# Service Bulletin

Bulletin No: 11 001 02 (002)

## BMW Motorcycles

**Subject: Slip-ring seal for oil/water pump, all K 75, K 100, K 1100 models.**

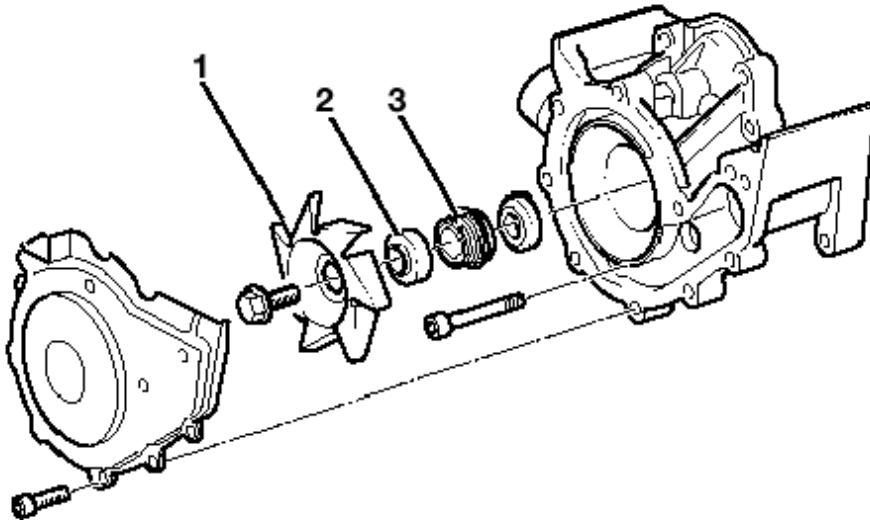
**Details:** All K 75, K 100, and K 1100 now share the the same slip-ring seal, spacer and impeller as the K 1200 RS/LT.

**Service Measures:** When making repairs to the oil/water pump, the updated slip ring seal (3) should be used. This updated slip ring **must** be installed in conjunction with updated spacer (2) and sheet metal impeller (1).

**Important note:** Use BMW special tool No. 11 6 724 to install the updated slip ring seal. Failure to do so will result in an incorrect seating of the seal. Refer to the K 1200 RS Service Manual for installation instructions.

Metal impeller (rotor): 11 41 1 461 173  
Picture reference #1

Spacer: 11 51 1 464 902  
Picture reference #2

Slip ring seal: 11 51 1 704 084  
Picture reference #3
